APPLICATION AND
PRELIMINARY PLAT CHECKLIST

Name of Proposed Subdivision HARRIS HEIGHTS SECTION II

File No. 83-66-PP

~~SITE PLAN~~/PRELIMINARY PLAT/~~FINAL PLAT~~-

PRELIMINARY PLAT				ROCKWALL, TEXAS	
HARRIS HEIGHTS ADDITION SECTION TWO					
DESIGN:	DRAWN:	SCALE:	DATE:		
H.L.E.	T.L.O.	1"=100'	10/24/83	328-0133 HAROLD L. EVANS CONSULTING ENGINEER DALLAS

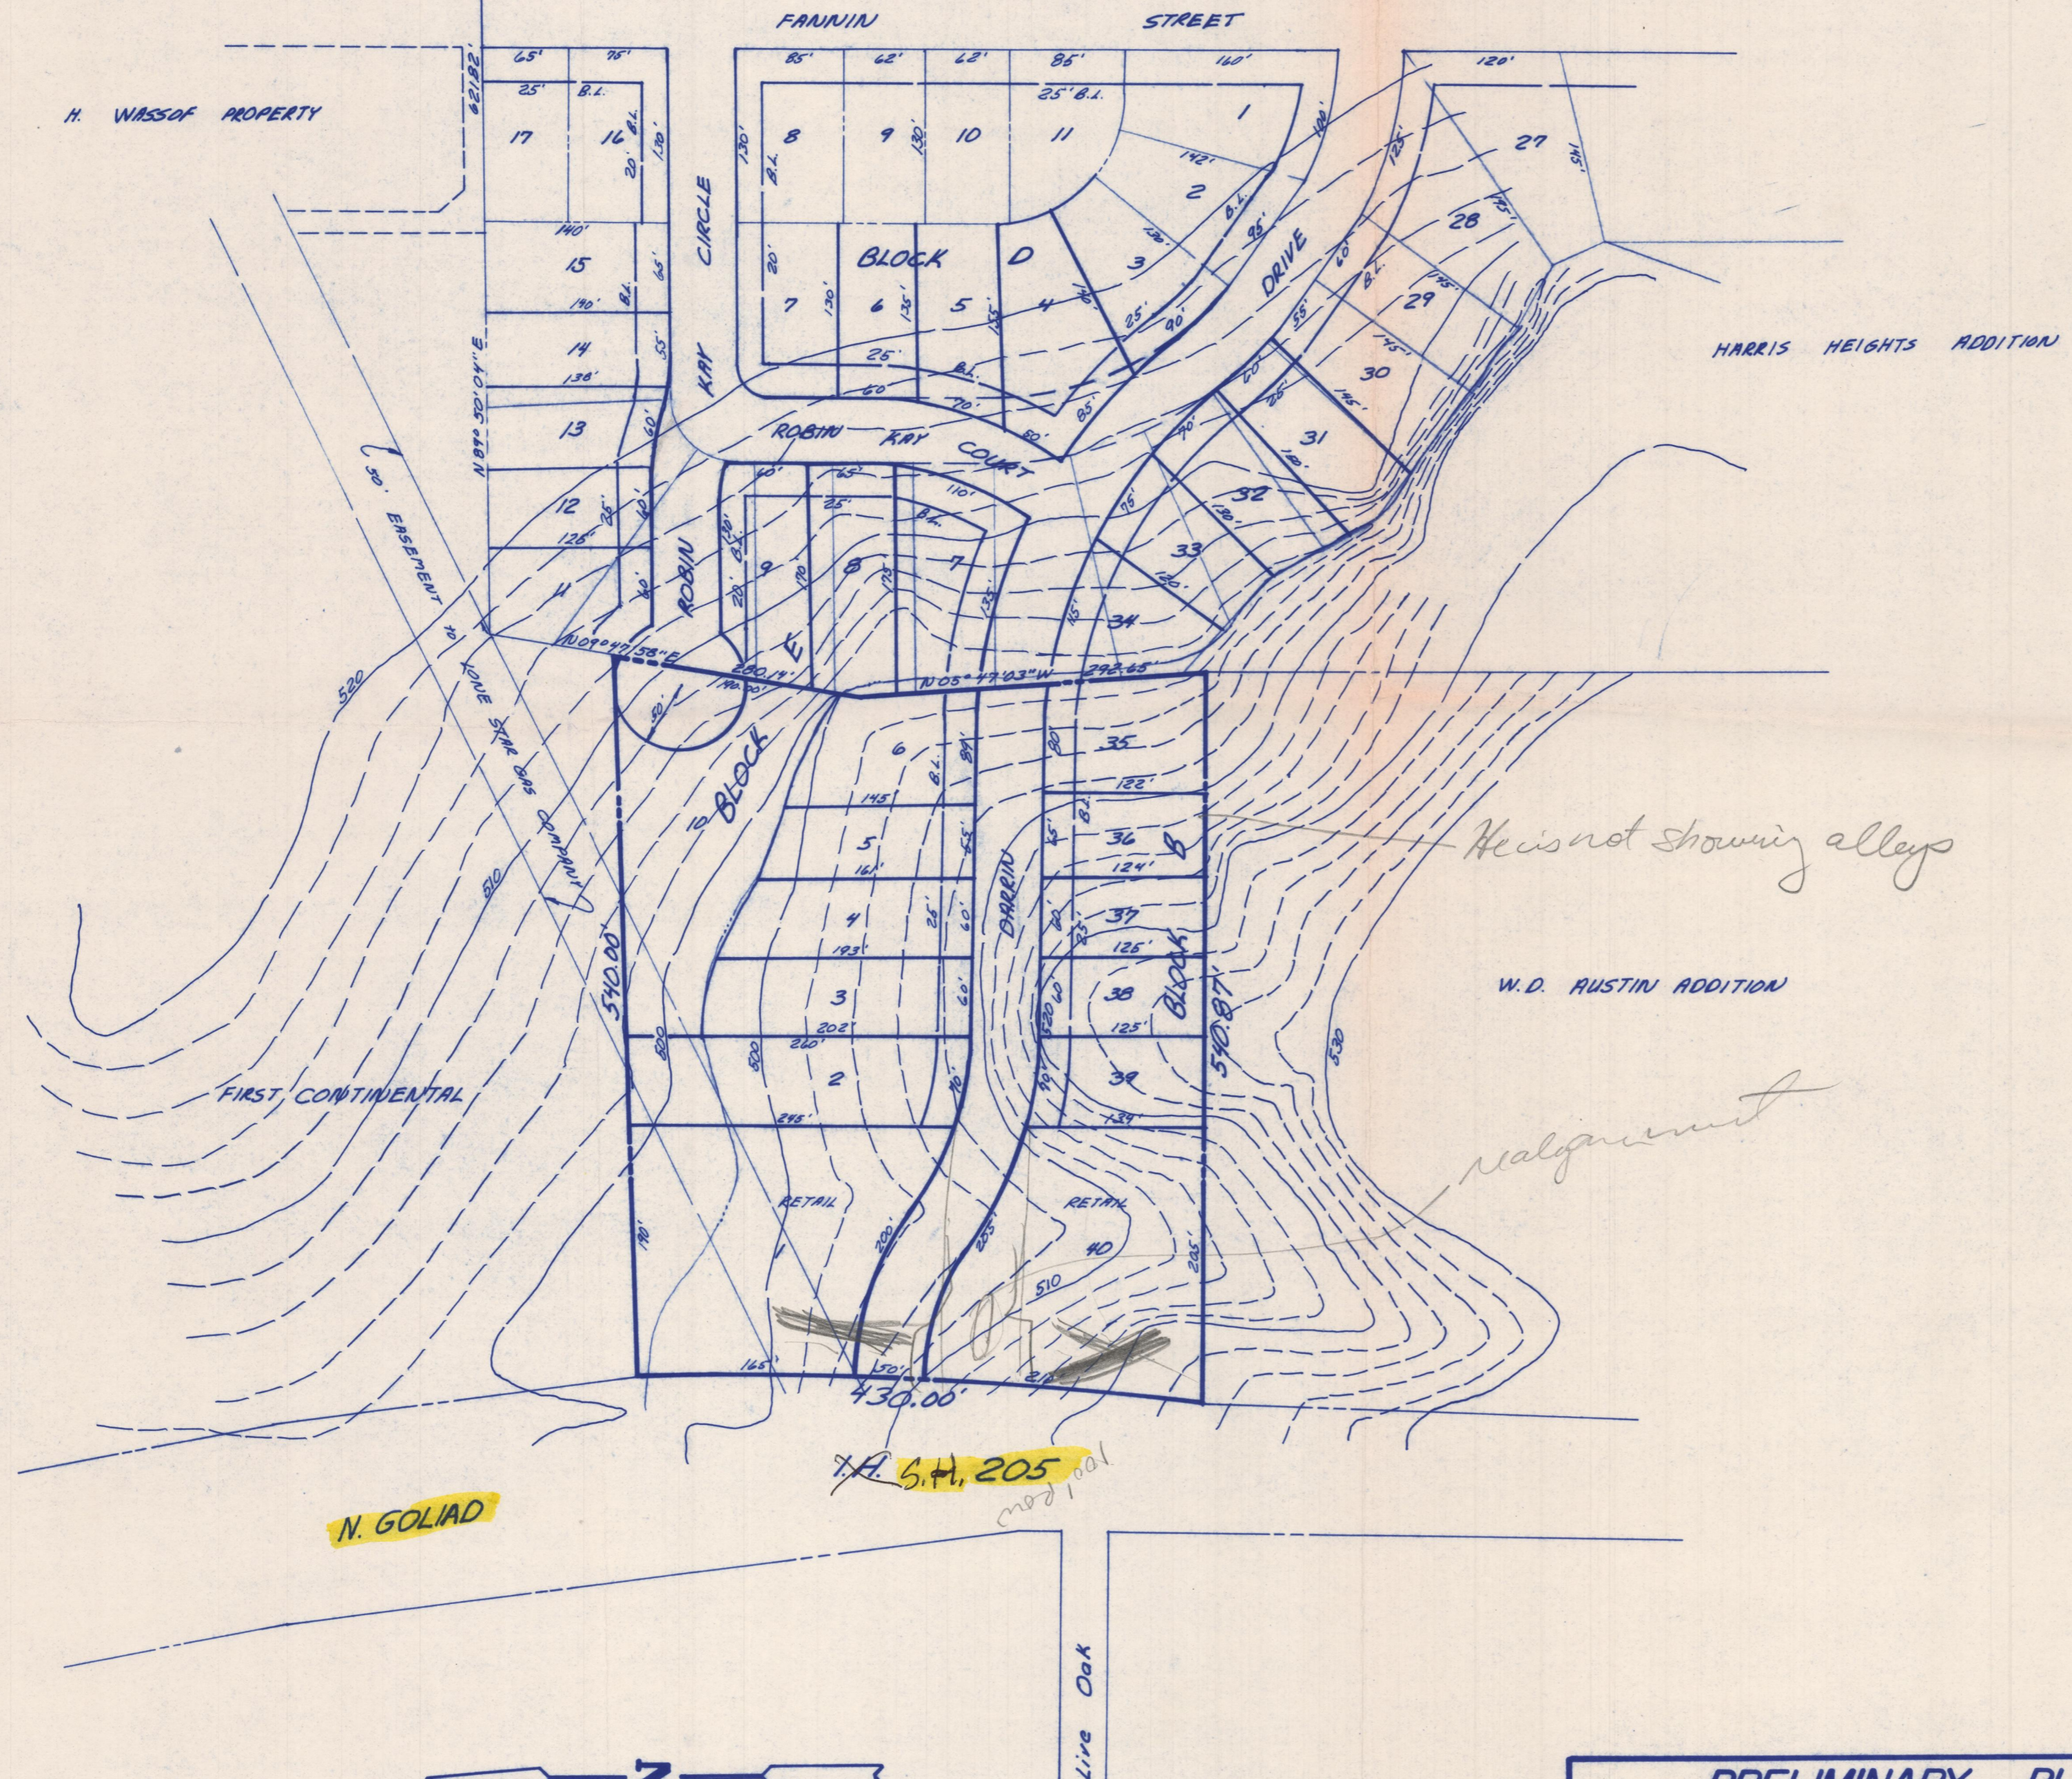
Staff Comments: Would increase access and help circulation through Harris Heights Addition and the Wade Addition, giving access to SH-205.

1. Offset intersection on SH-205 with Live Oak.
2. ~~Plat needs street dedication, room for signatures on final plat.~~
3. ~~A time restriction needs to be put on the entrance walls, telling when they will be removed~~
4. No alleys.
